**WHEELING PLAN COMMISSION
THURSDAY, JUNE 28, 2018 6:30 P.M.**

**AGENDA FOR A REGULAR MEETING OF THE PLAN COMMISSION
Board Room - 2 Community Boulevard, Wheeling, Illinois**

REQUEST FOR PLAN COMMISSION ACTION
STAFF PROJECT REVIEW

RE: **Docket No. SCBA 18-9**
The Whitley of Wheeling
156 W. Dundee Road
Appearance Approval of a Freestanding Sign

SHEET NUMBER:
A0.1

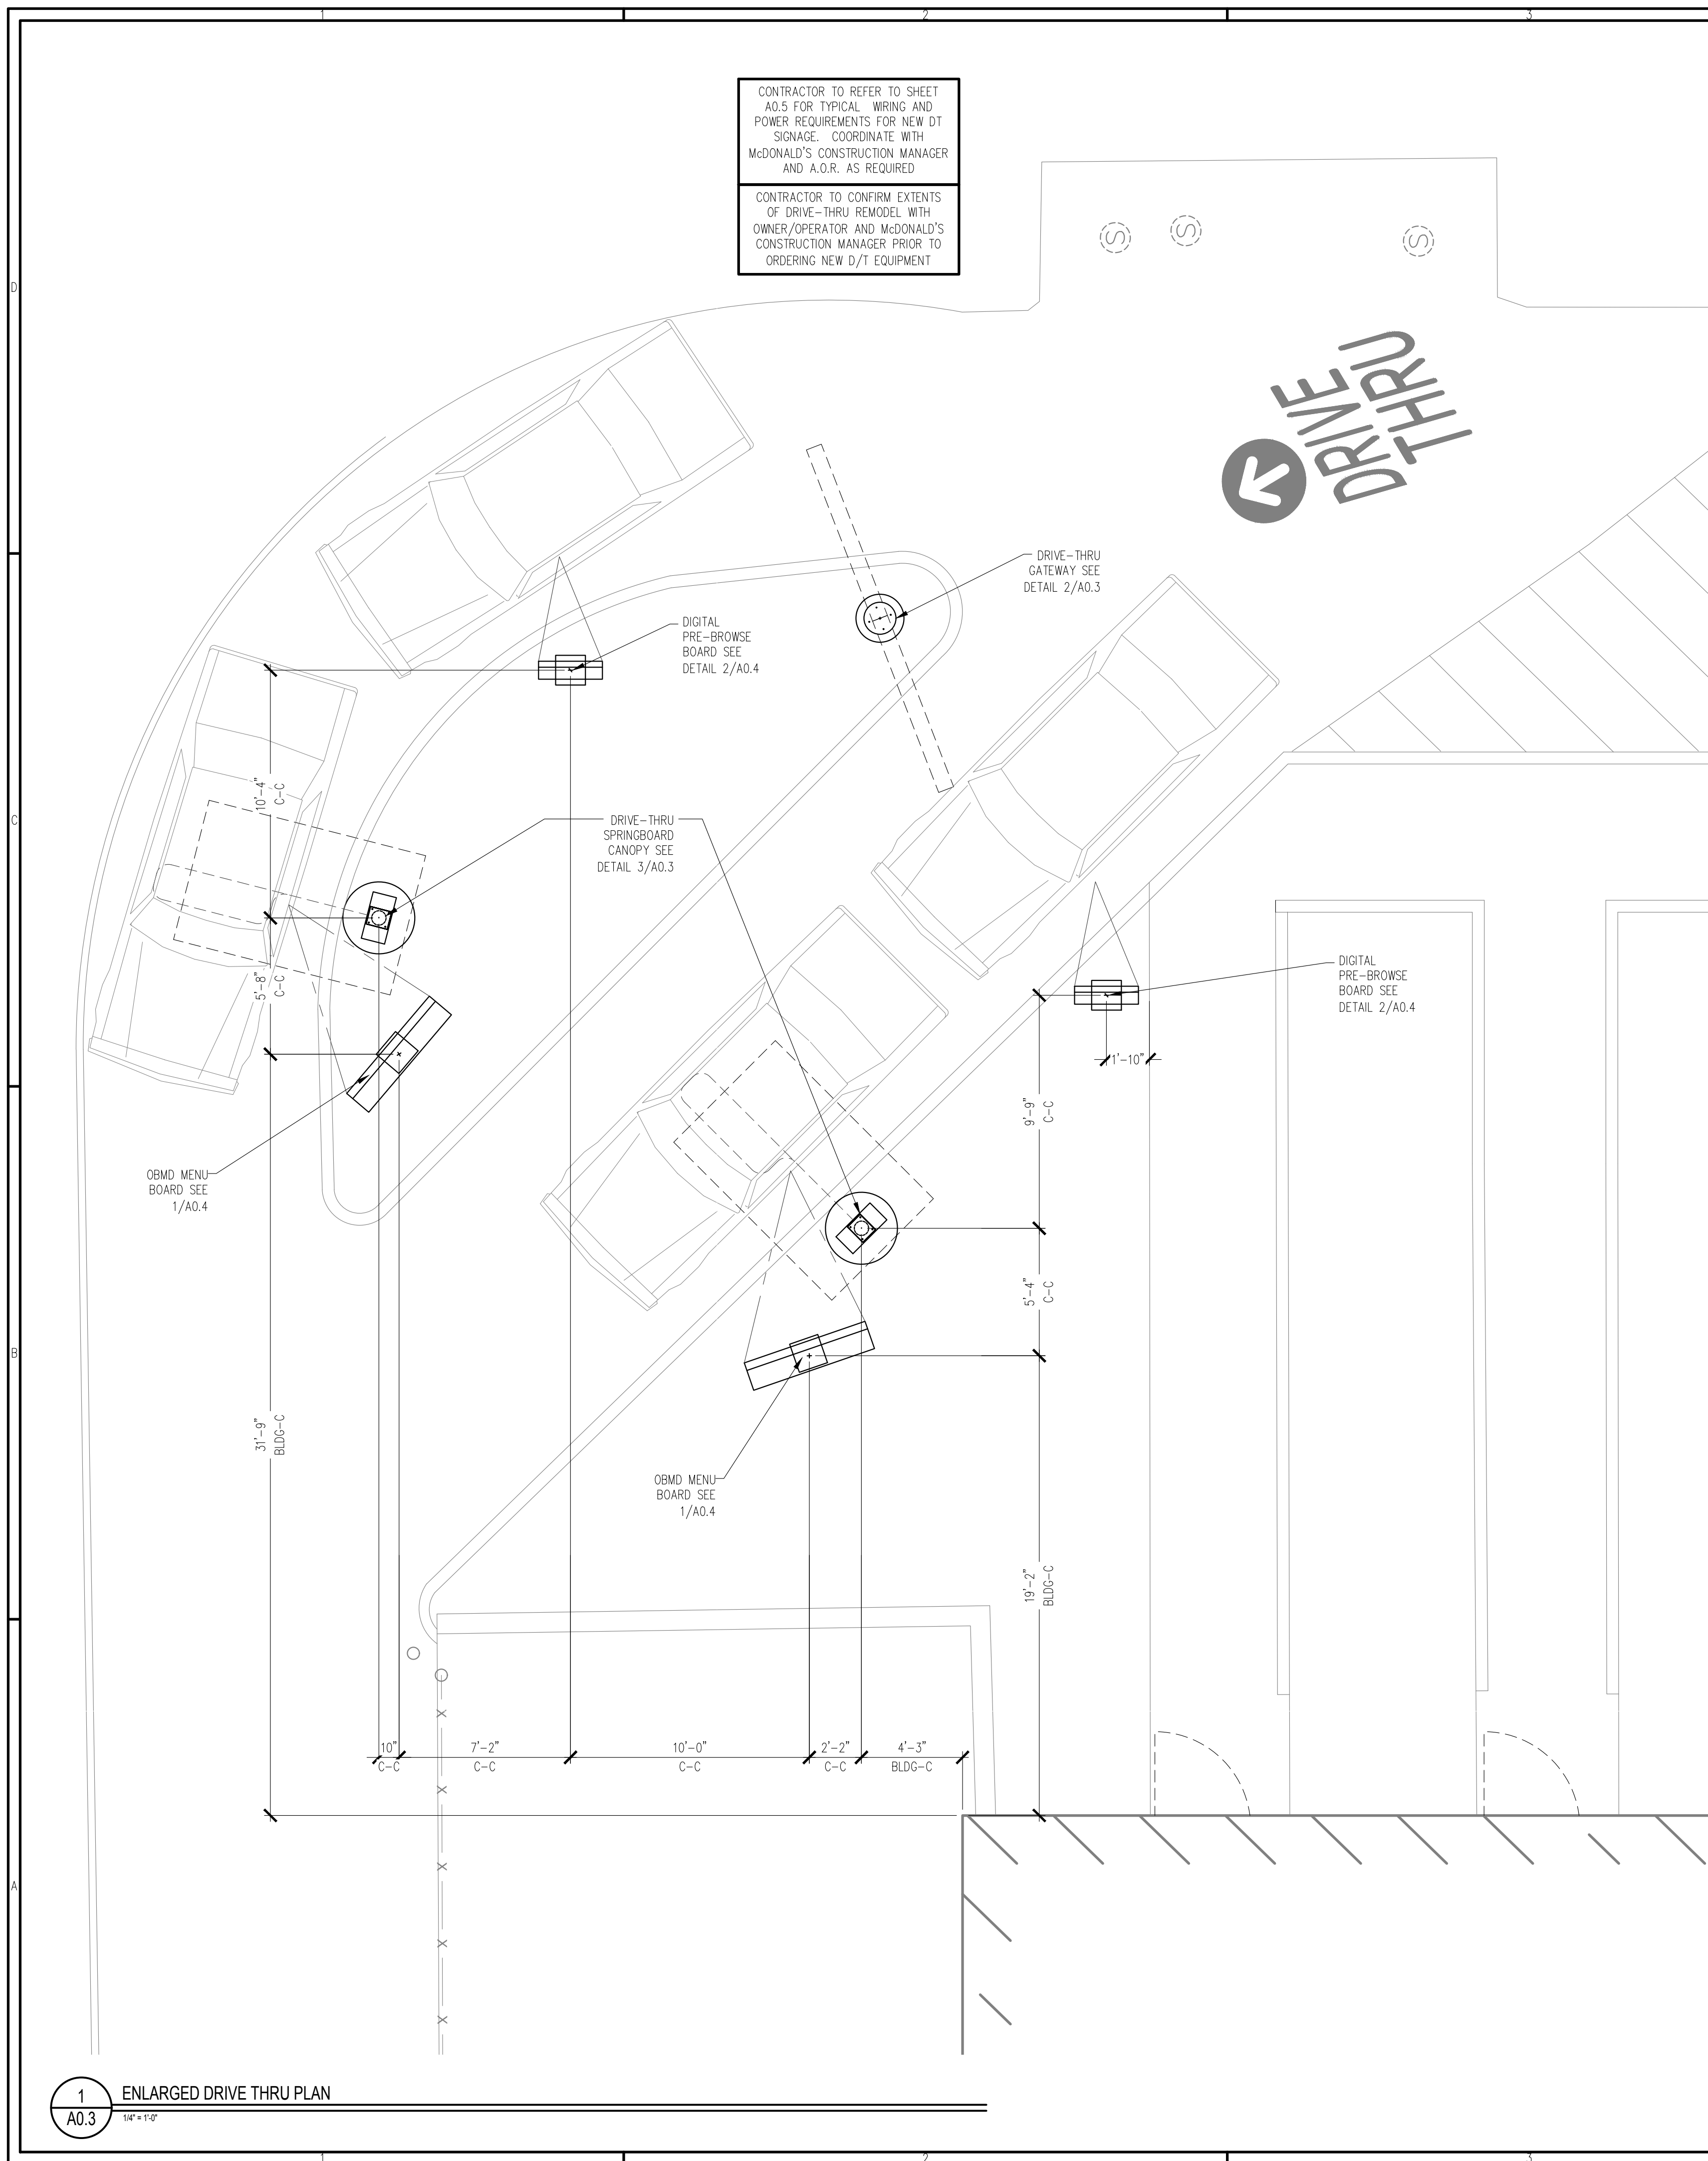
General site layout: No changes are proposed to the configuration of the site. The site plan, Sheet A0.1, indicates minor work is planned to improve pedestrian access. A new concrete sidewalk is proposed east of the parking lot, providing access to Lake Cook Road. The end of the new sidewalk will be striped for safe access across the driveway. New handrails will be installed near the entries. A railing detail is provided on Sheet A0.2. The existing drive-through signage will also be replaced. The new signs are located in generally the same locations at the existing.

1
A0.4 **DIGITAL MENU BOARD**
SCALE: NONE

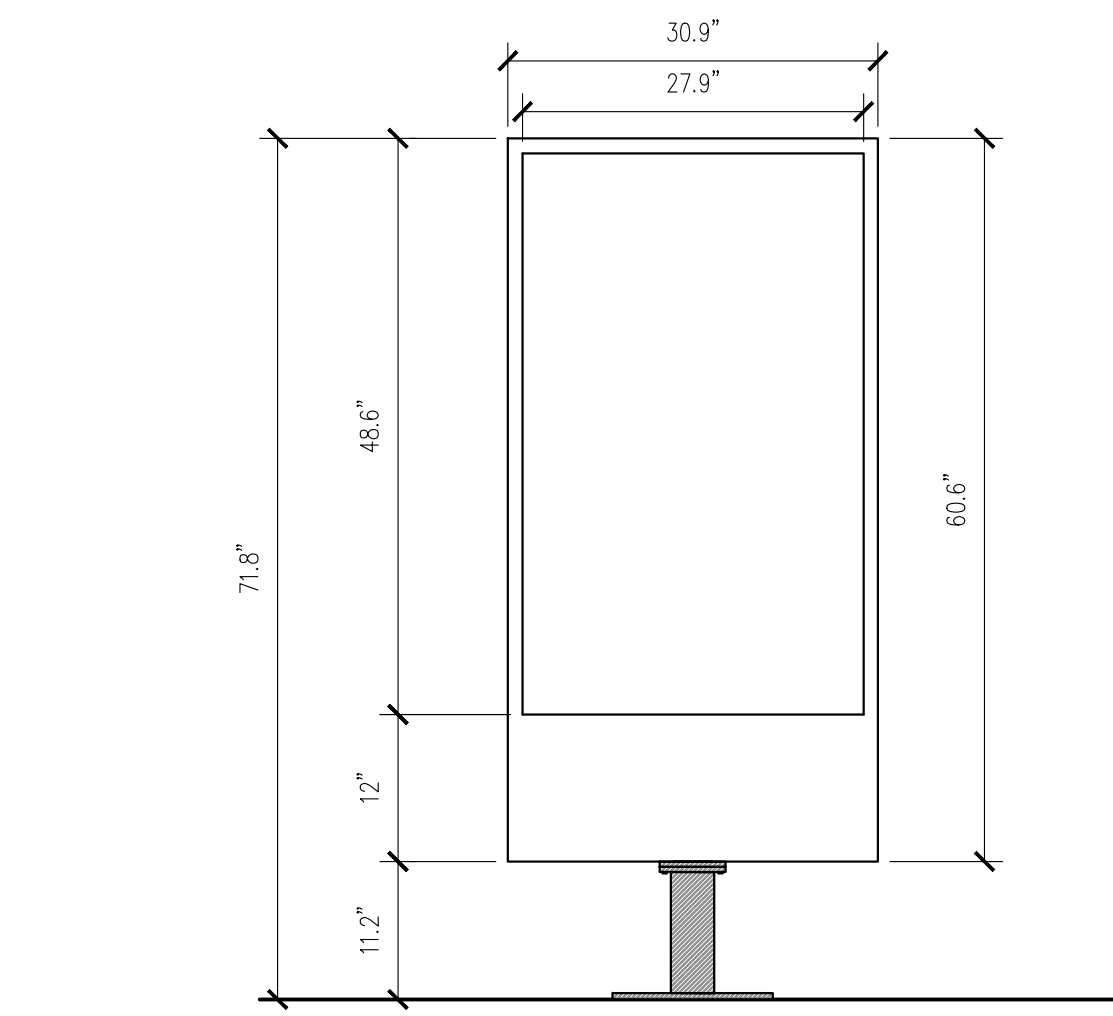
Sign Type and Locations: Several replacement signs are proposed in the area of the existing drive-through lanes. The plans are provided on Sheets A0.3, A0.4, and A0.5. A new double-armed gateway point for the drive-through and “order here” canopy are proposed. The existing menu-boards and pre-browse boards will be replaced with digital boards. The menu boards are less than the 60 sq. ft. size allowed by the Sign Code.
